COUNCIL ASSESSMENT REPORT

SYDNEY CENTRAL CITY PLANNING PANEL

PANEL REFERENCE & DA NUMBER	PPSSCC-399 - DA 717/2023/JP
PROPOSAL	Residential Flat Building Development Containing 364 Units and Basement Parking
ADDRESS	Lots 301-313 DP 252593, Lots 202-207 DP 249973, Lot 505 DP 258587 Nos. 20-36 Middleton Ave, 1-19 Hughes Avenue and 34 Dawes Avenue Castle Hill
APPLICANT	UPG 345 Pty Ltd
OWNER	Hughes 888 Pty Ltd, Mr J Gatt, Mrs N Gatt, Mr R M Scott, Mr G D Powell, Mrs M M Powell, Spintaro Pty Ltd, Mr D J Quinn, Mrs R J Quinn, Mr A Oon, Mrs A J Oon, Mr M J Butcher, Mrs M Ramsden, Mr D H Simpson, Mrs J A Simpson, Mrs B Kay, Est Late Dr L K, Ho, Mr T D Cody, Mrs J M Cody, Mr G A Nugent, Mrs N E Nugent Mr R E Buxton, Mrs S J Buxton, Mrs A C Emanuel, Mr J J Vella Mrs P H Vella, J & W Xie Holdings Pty Ltd, Mr A B Cicco, Mrs L Cicco, Mrs Z Matic
DA LODGEMENT DATE	19 October 2022
APPLICATION TYPE	Development Application
REGIONALLY SIGNIFICANT CRITERIA	Clause 2, Schedule 6 of the SEPP (Planning Systems) 2021

DATE OF REPORT	23 November 2023

ATTACHMENT 6 – LANDSCAPE PLAN

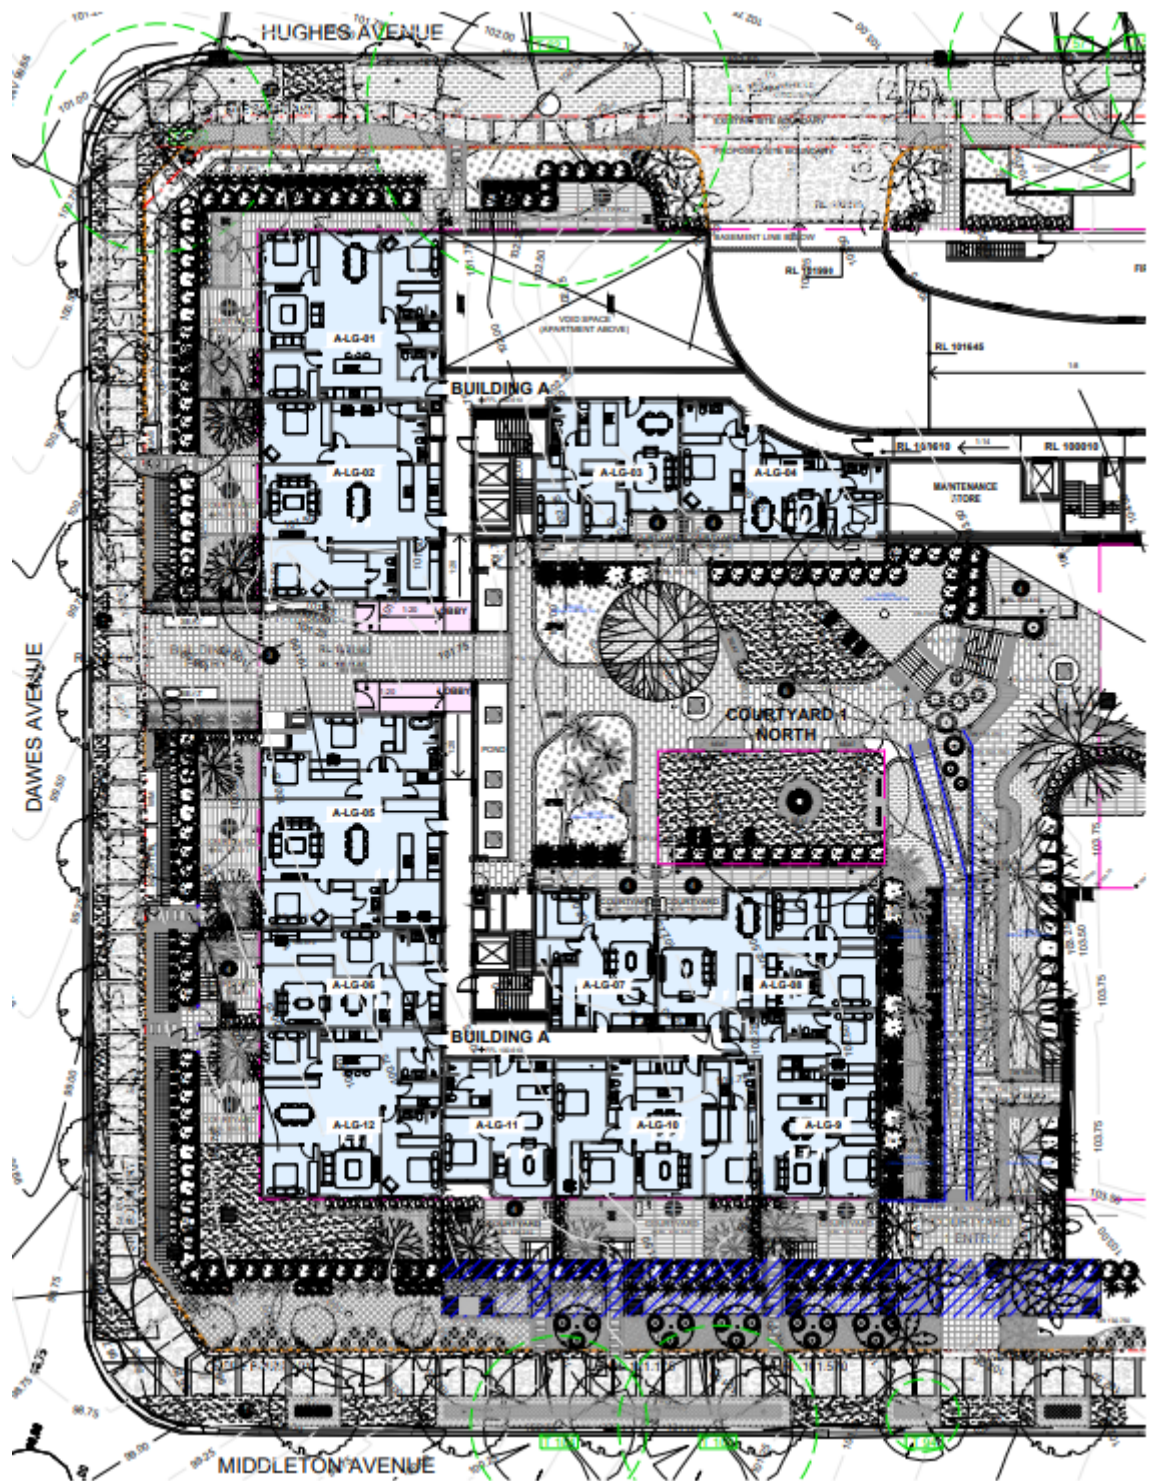
The Arborist Report does not appear to assess all trees on the site, on the Council nature strip and the vicinity of the boundaries, and a tree location plan has not been provided. Accurate Tree Protection Zones (TPZ) have not been coordinated on all plans, including civil plans, and TPZ encroachments in accordance with AS4970-2009 Protection of Trees of Development Sites have not been provided. This must be provided to allow an assessment of any proposed tree retention and removal on the site, on neighbouring properties, and Council nature strip. Insufficient levels information is provided outside of the building footprint on all plans to demonstrate that natural ground levels are being maintained with the TPZ of trees and the proposed stormwater infrastructure locations do not avoid the TPZs of trees as recommended in the Arborist Report.

Trees proposed for retention and removal between plans are inconsistent, and insufficient investigations as to which significant trees in deep soil areas could be successfully retained under the development appears to have been undertaken. Architectural sectional drawings appear to indicate walls/level changes on almost all boundaries, which are not located on other plans. These walls and levels changes would impact on tree on the site, neighbouring sites, and on the Council nature strip.

The landscape plan does not provide sufficient information in accordance with the Apartment Design Guide, THDCP Part B Section 5 – Residential Flat Building, THDCP Part D Section 19 – Showground Station Precinct and THDCP Part C Section 3 – Landscaping such as the following:

- Clearly located basement under and basement slab levels to allow an assessment of achieved soil depth over.
- Retaining wall levels for all retaining walls in the landscape and proposed materials and finishes.
- Details landscape planting plans which locate individual planting and associated plant quantities.
- Street trees in accordance with Showground Precinct Public Domain Plan

New Comment: This comment remains relevant. It appears that the location of the OSD within the western frontage setback may constrain the effectiveness of planting within the setback area. Setback zones are to maximise soft landscape and enable planting that can mitigate the facades from the street.

New Comment: This comment remains relevant. As noted above, the incursion of paved courtyards and pathways reduces the effectiveness of landscape within the setback and impacts its planning intent.

- It is commended that a large area of DSZ is provided centrally, however it is unclear what benefit this brings to the project. DSZ is predominantly for the retention or establishment of large trees. The area in questions appears to do neither. Furthermore, it is covered in part by paving thus negating its ability to act as a DSZ. Its collocation with COS brings great opportunity which should be taken advantage via the provision of a beautiful and usable central COS accompanied by large trees.

- The proposed Turpentine tree species may limit winter solar access to an area with already limited winter solar access – it is unclear how the positioning of proposed planting works with the available solar access.

- While some seating has been added it does not appear for a development of this scale that there is an adequate amount or variety of seating opportunities provided. Variations including backed seating, benches and broader seating and lying platforms and lounges should be explored.
